# READING VILLAGE ARCHITECTURAL PEER REVIEW PHASE 2

Report by:  
**TBA Architects, Inc.**  
43 Bradford St. Suite 300  
Concord, MA 01742  
P: (781) 893-5828

Submitted to the Town of Reading on July 15<sup>th</sup>, 2016

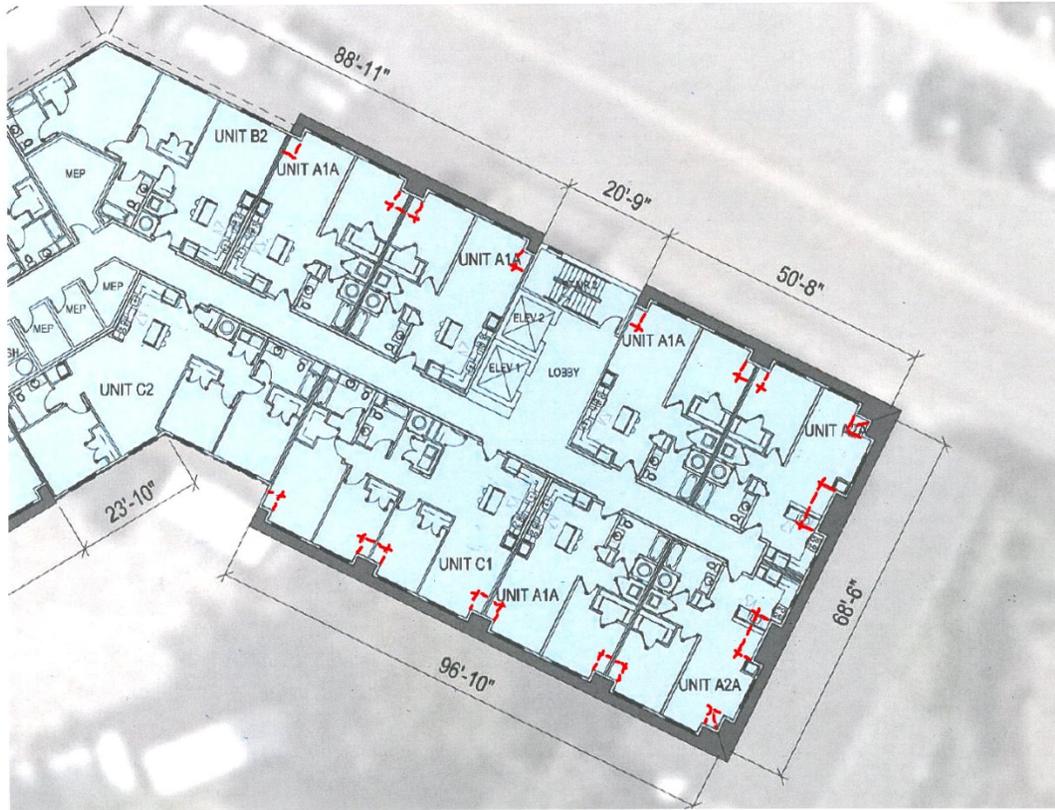
- i. The corner parcel has been included in the project which decreased the scale from the previous submission which is an improvement given the scale of the community and neighborhood.
- ii. The Prescott St. and Lincoln Street elevations were submitted, but the rear elevation was not included and would be very helpful to see
- iii. The residences abutting the site are all under 35 feet high, and fit within the neighborhood zoning height and the commuter rail station across Lincoln Street is approximately 22 feet. This reduced scale of the proposed building fits into the neighborhood and is a clear improvement over the previous design.

- iv. A sun shadow study was included in the previous submission but was not submitted for this submission. Such a study would be appropriate, particularly to assess the impact on neighboring properties and the viability of the proposed landscape solution.

- v. We observe that the proposed site access is limited to vehicles that can pass into the parking lot. This limits access by public safety and service vehicles. (See additional comments below). Raising the first floor level to increase clearance into the parking area will increase building height, affecting the building scale.

- vi. The roof configuration is an important feature to establish the building scale. As proposed, the shingle roof and dormer configuration successfully reduces the apparent scale of the fourth floor level. See detail image (a) below. This has an impact on fourth floor unit size which may not be fully captured in the Unit Mix Summary. See enlarged partial plan (b) below, which illustrates in red the sloped ceiling associated with this configuration.

Certain of the eave areas shown in red may have a height of under five feet. This may reduce the functional size of the rooms. Making the roof steeper would reduce this problem but will have an important impact on the building's perceived scale.

- i. Clarify the vehicular clearance to the parking area and provide revised building elevations if the first floor level is revised.
- ii. Provide a fourth floor building section at the pitched roof to clarify the effect on interior occupancy and furnishing. Update the top floor to include ceiling heights and show where ceiling heights change.
- iii. Provide a sun shadow study for this new proposed design to show the impact on the neighboring sites and landscape plan.

Sheet Title  
LANDSCAPE  
PLAN  
Scale: 3/32"=1'-0"  
Date: JUNE 21, 2016  
Revision:  
Sheet Number  
L-1

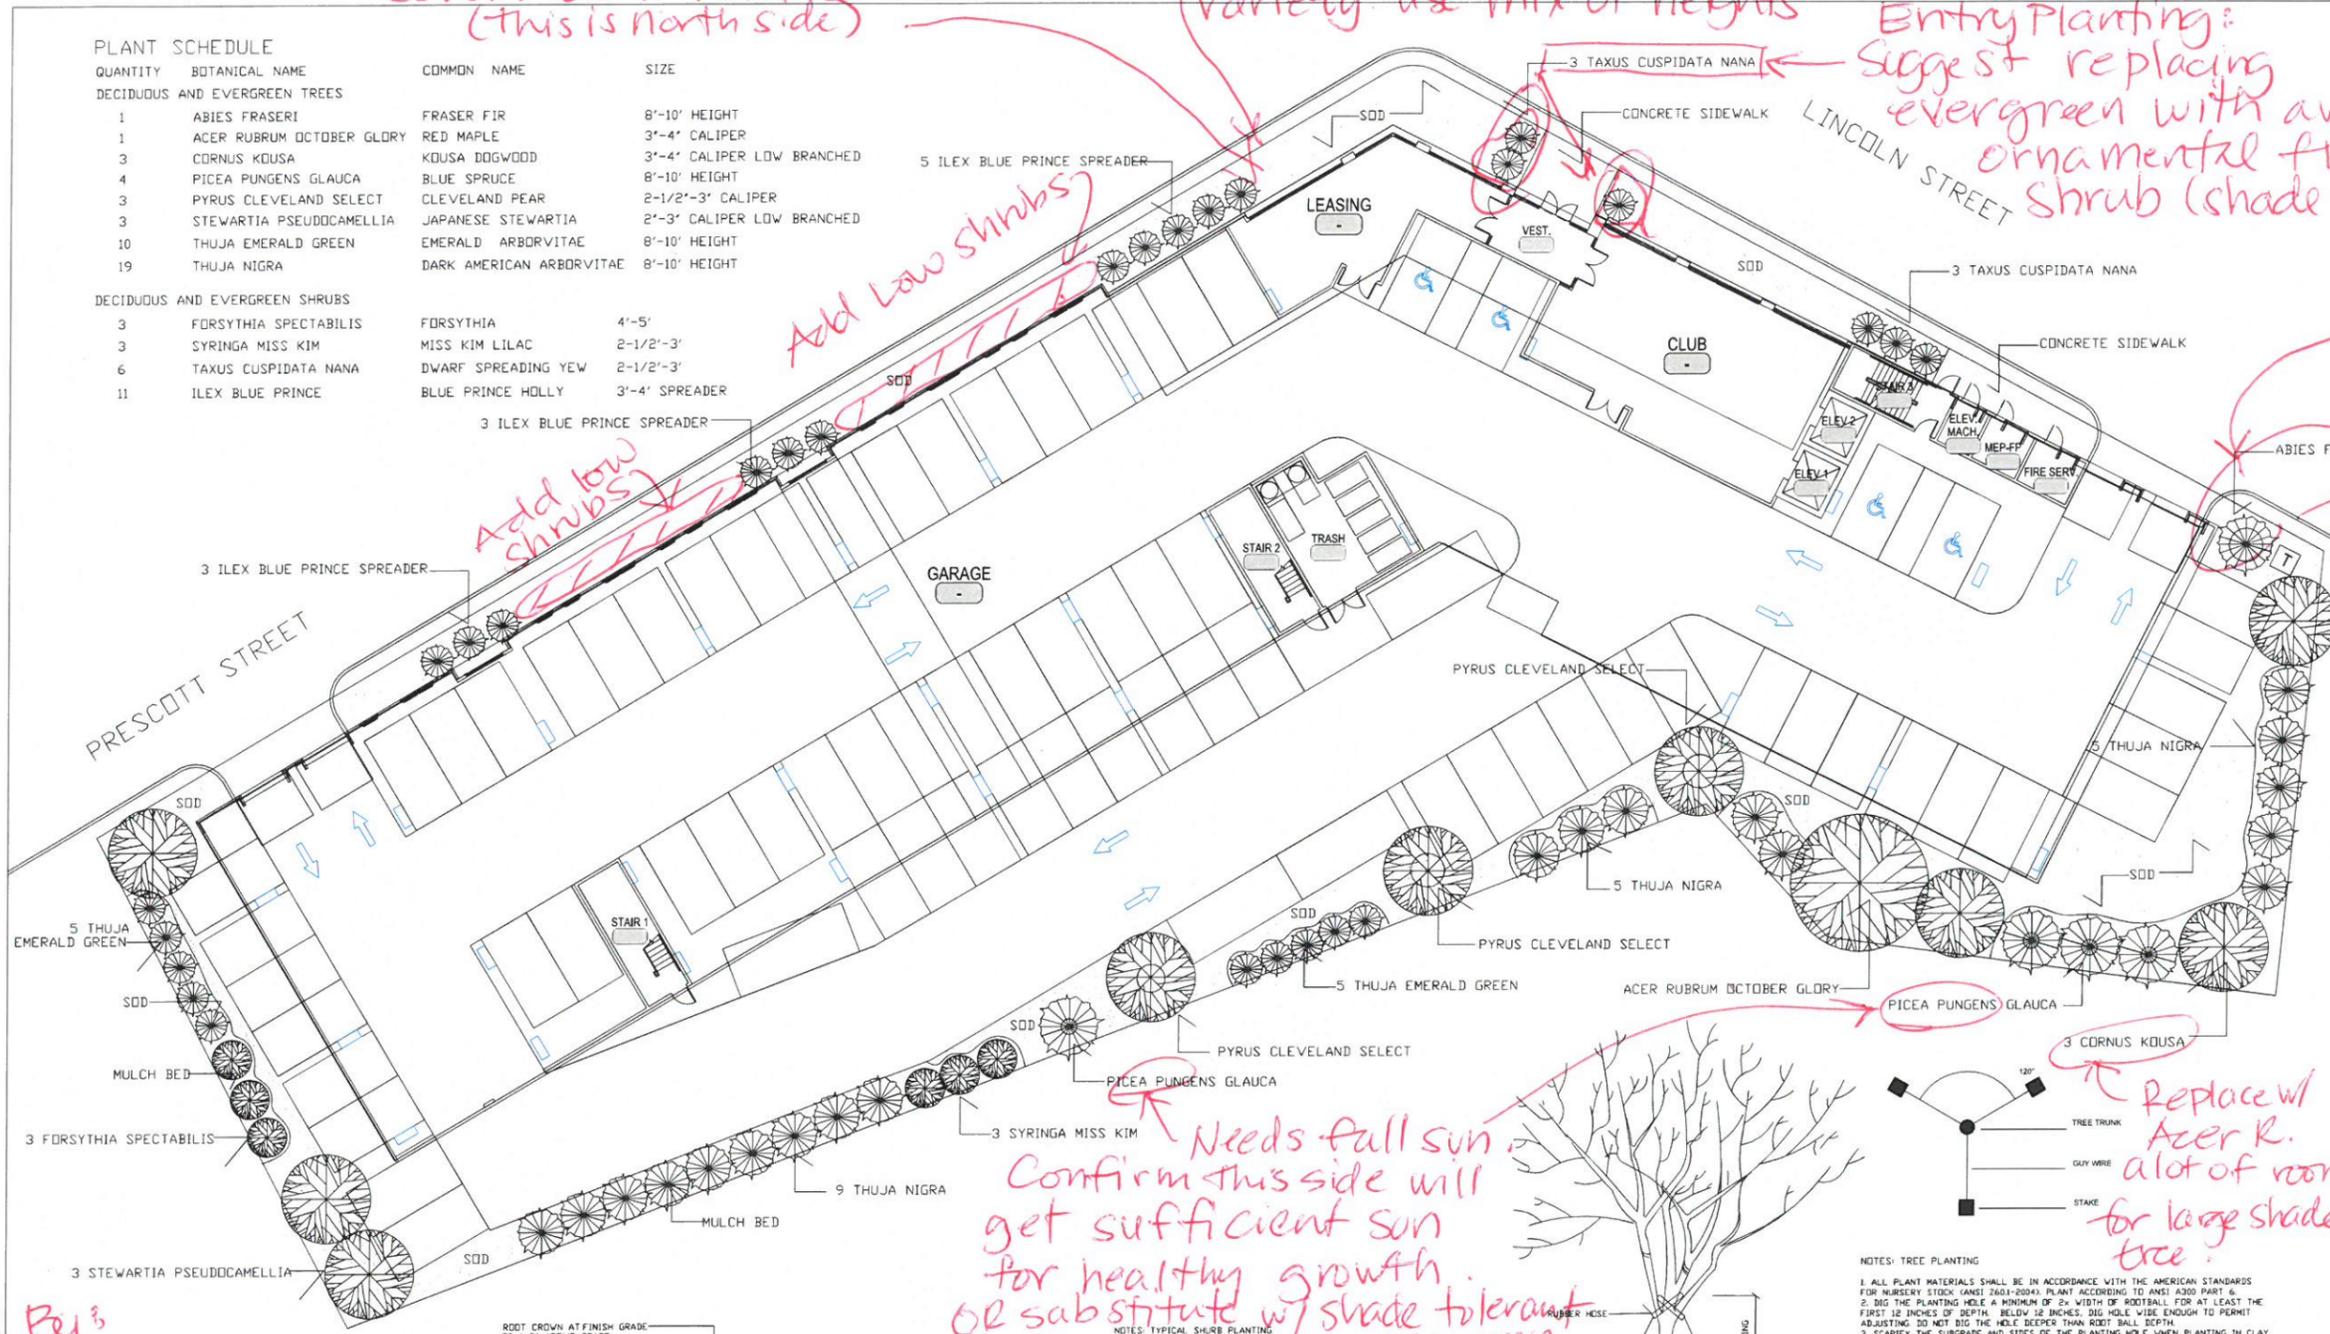
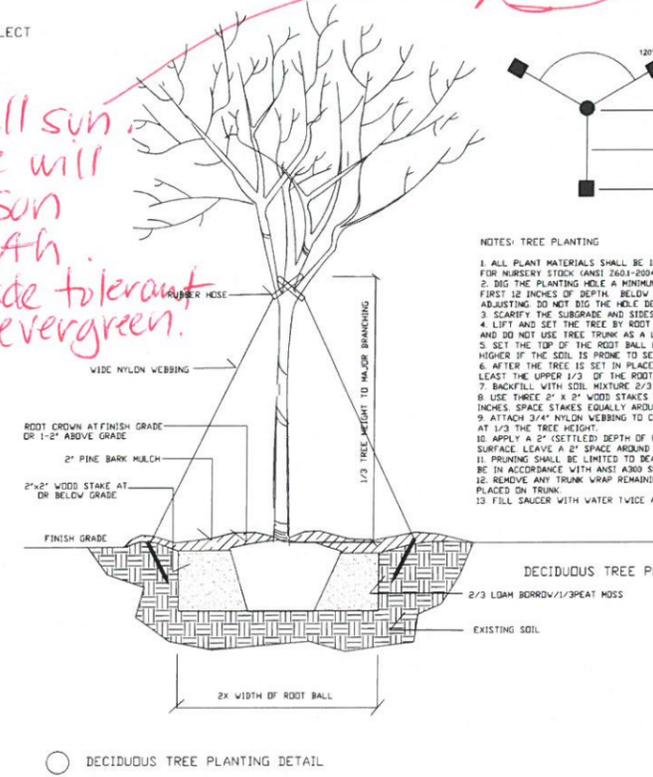
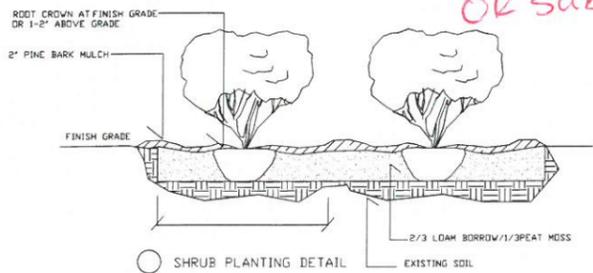
- i. The shrubs chosen for along the sidewalks are Ilex Blue Prince which tend to grow horizontally and can become quite large, which will displace the sidewalk if not frequently pruned.
- ii. Evergreen placed at the corner of the property where at the parking lot exit onto Lincoln St. will block sight lines for oncoming cars. Consider a lesser visual barrier.

Suggest substituting SOD to a shade tolerant ground-cover, Carex varies or other. (this is north side)

Front Planting - Ilex Blue Prince too large & wide for this location. Suggest using smaller, upright variety use mix of heights

Entry Planting: Suggest replacing evergreen with an ornamental flowering shrub (shade tolerant)

This evergreen block site street. Ref with low sh decid tree watch other

Needs full sun. Confirm this side will get sufficient sun for healthy growth. OR substitute w/ shade tolerant evergreen.

Replace w/ Acer R. a lot of room for large shade tree

- i. For the shrubs along the sidewalks consider planting taller, more upright growing shrubs that are easily maintained and will not disrupt the sidewalk. Consider planting lower shrubs between the taller shrubs to create more of a landscaped screen in front of the false windows going into the parking garage.
- ii. Along the back of the property, verify with a sun shadow study that the Picea Pungens Glauca will receive full sunlight as needed for it to be healthy. Although this is located on the south-facing side of the site, adjacent properties have substantial trees that will shade the area.
- iii. Consider in lieu of mulched sod at the base of the shrubs, plant a low shade tolerant ground cover.
- iv. Consider a more ornamental planning at the building entry.
- v. See attached Landscape Plan for more detailed notes.
